WOODMEN HILLS METROPOLITAN DISTRICT

LIFT STATION #1 REPLACEMENT

LANDSCAPING PLAN & NOTES

PCD File No. PPR1841

C18

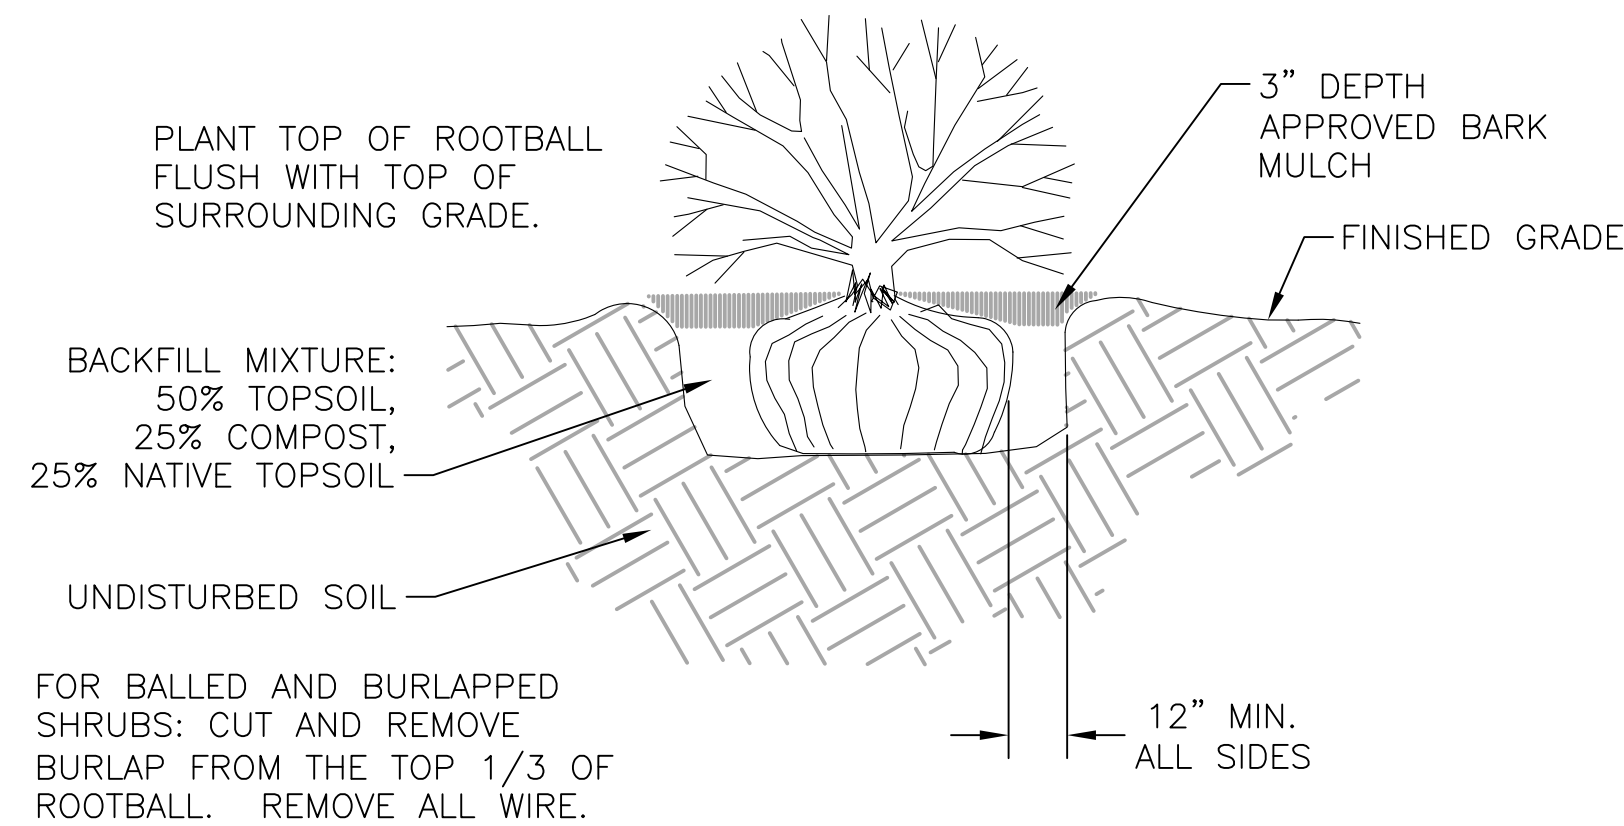
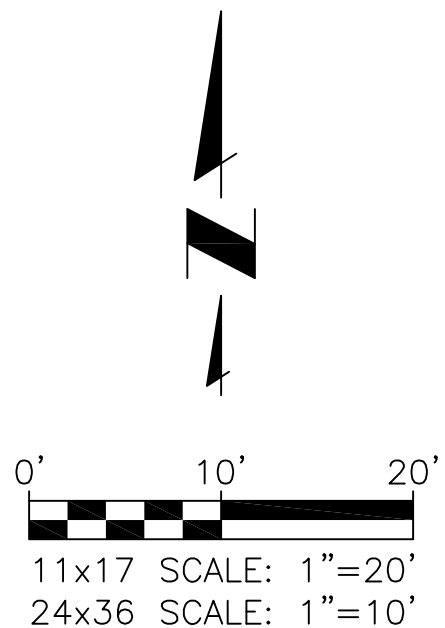
One tree per 500 sf of internal is required. The plan shows that the 4 trees are for internal landscaping. If they are for roadway landscaping as the table suggests, mark them on the plan as roadway landscaping.

The roadway landscaping requirement is within 20 feet of the roadway, if this is not possible, mark in the letter of intent that you are requesting an alternative landscaping plan, and mark this plan as "Alternative Landscaping Plan".
